TR 089-1(13)
This sheet for information only
BR 11 N & S

SHEET 97 OF 101

PROJ. I-89-1(a)	
N. B. E. S. B. BRIDGES	
INTERMEDIATE CROSS FRAMES	
Bancroft & Martin Inc. South Portland, Maine	
I-89 BRIDGE OVER WHITE RIVER HARTFORD, VERMONT	
CUSTOMER	CIANCHETTE BROS. INC.
DESIGNER	VERMONT DEPT. OF HIGHWAYS
ORDER NO.	Verbal
DWG. NO.	65-374-S53

INTERMEDIATE FRAME CF20
20 REQ'D

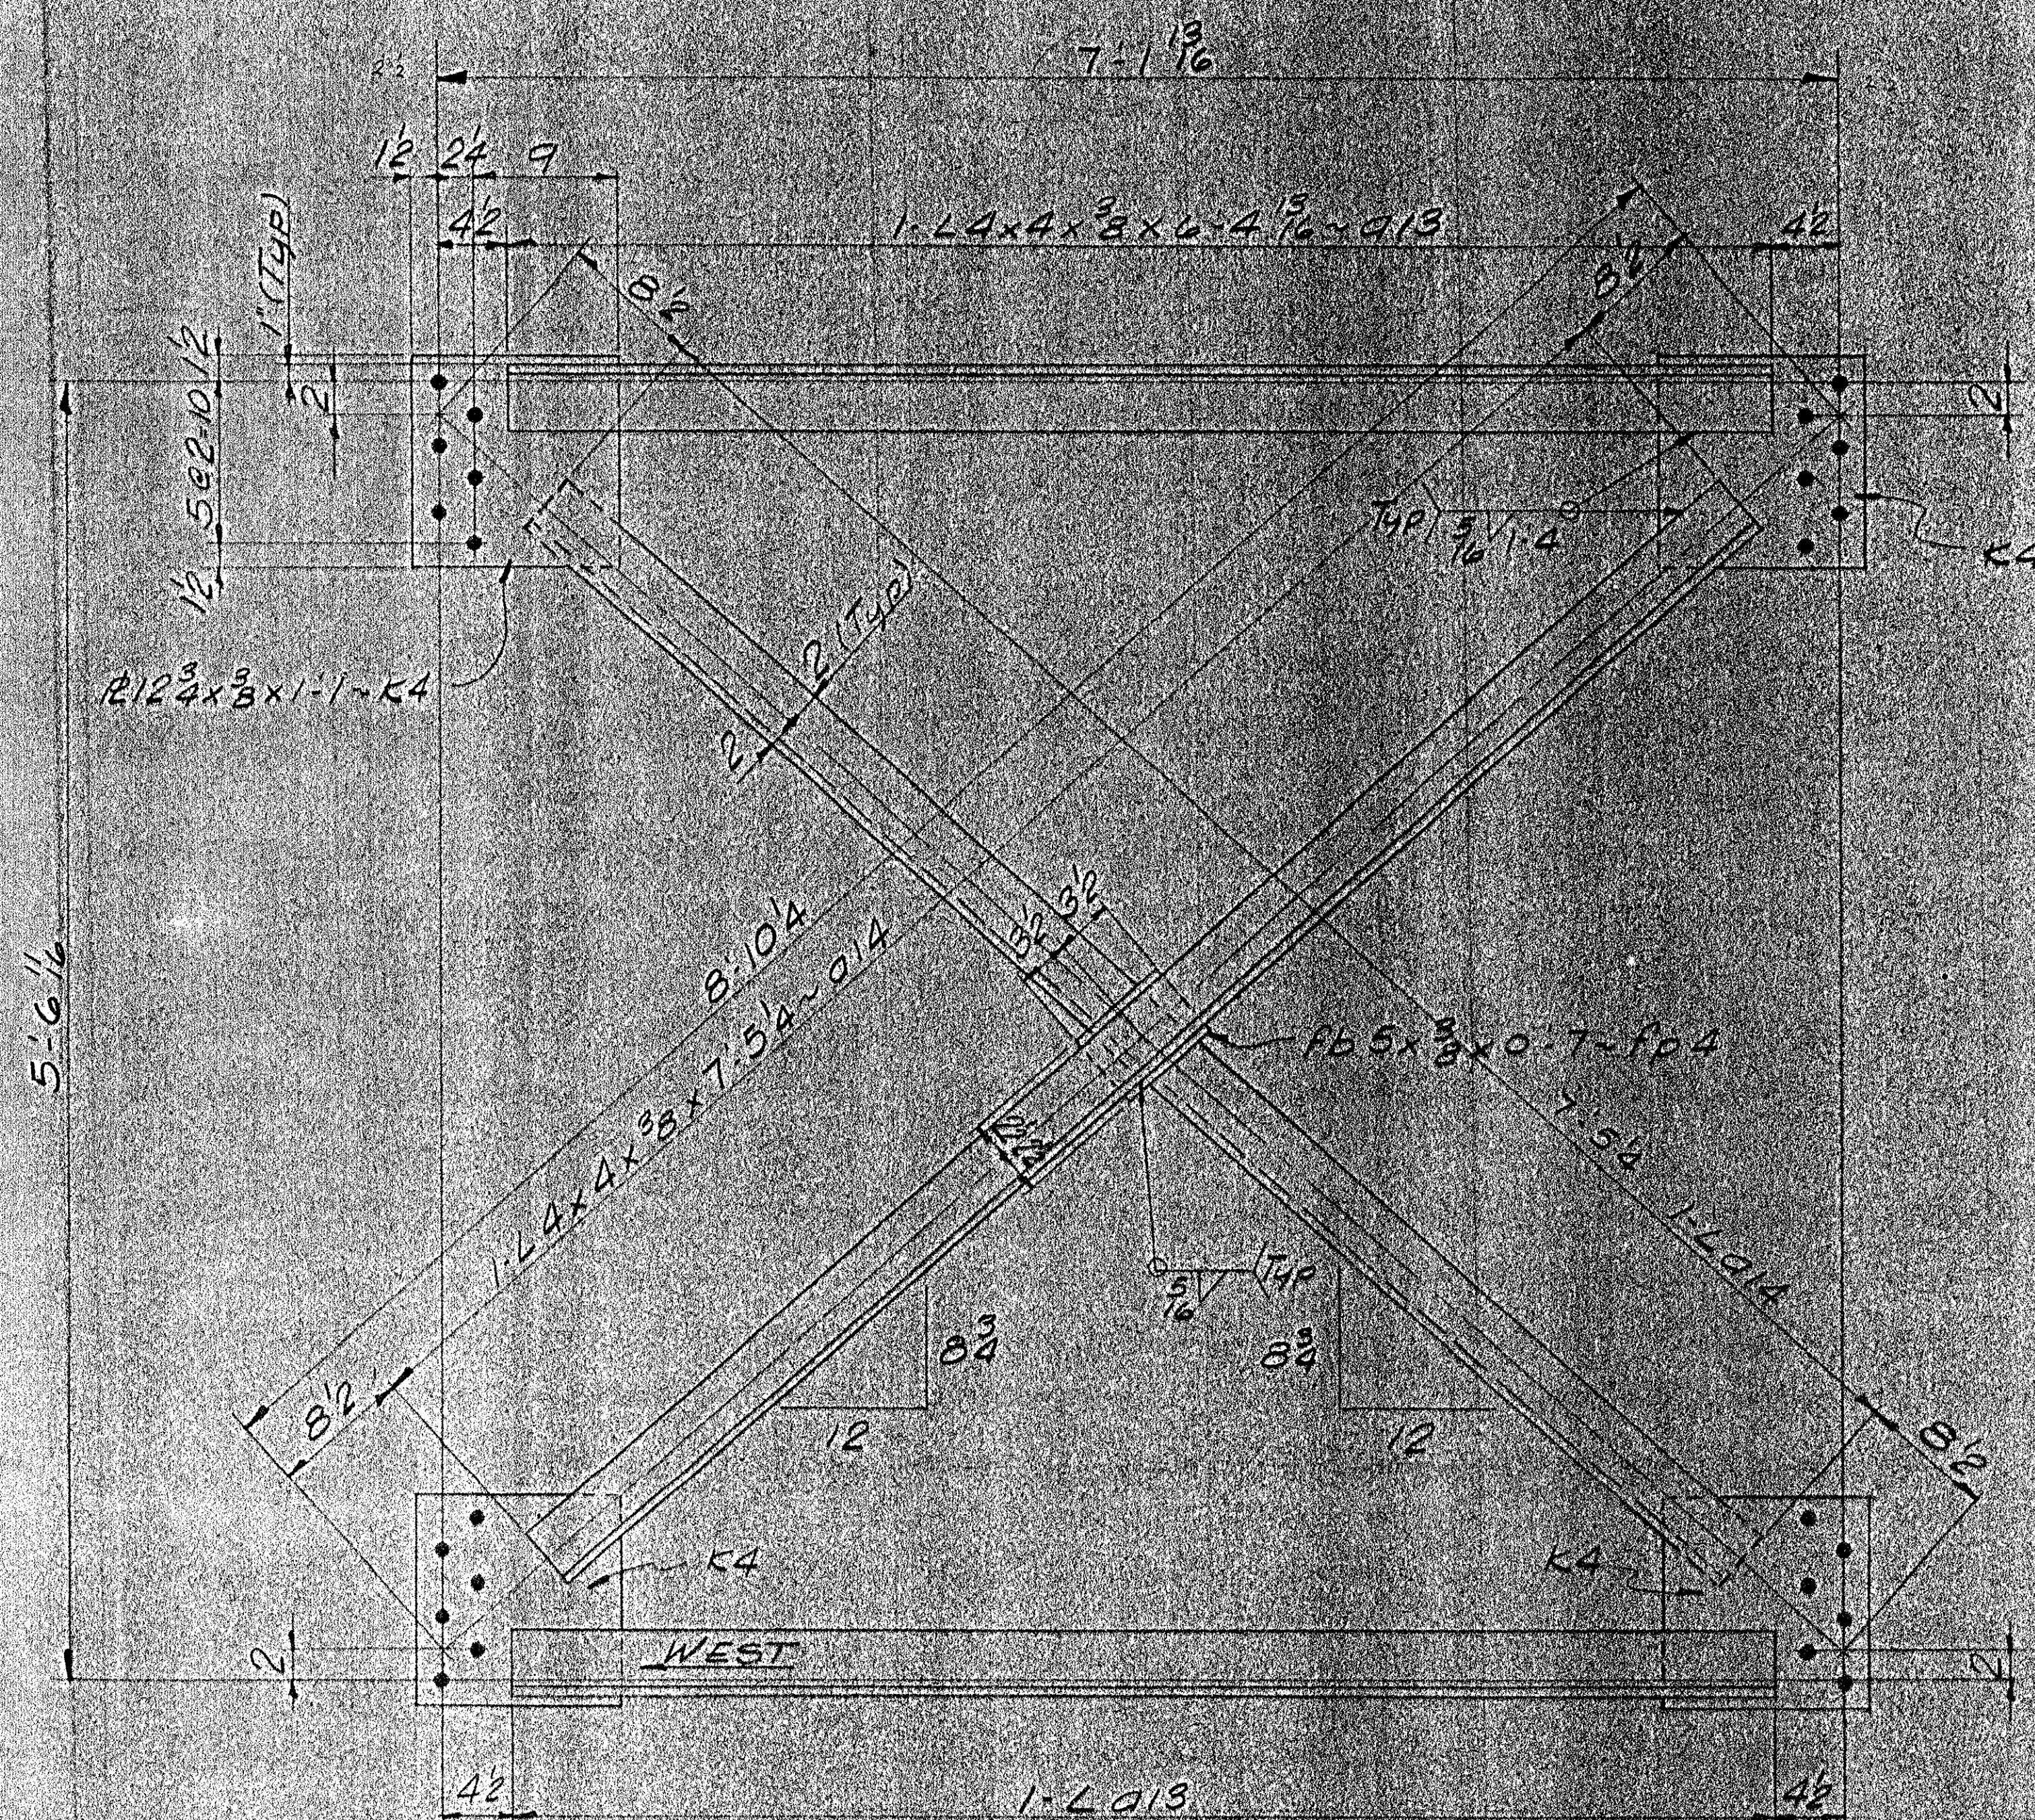
RECEIVED MAR 28 1966
CHK'D BY WET OK'D BY RLD
REUBMIT BY WIS APPROVED 1/2
DATE 4.5.66
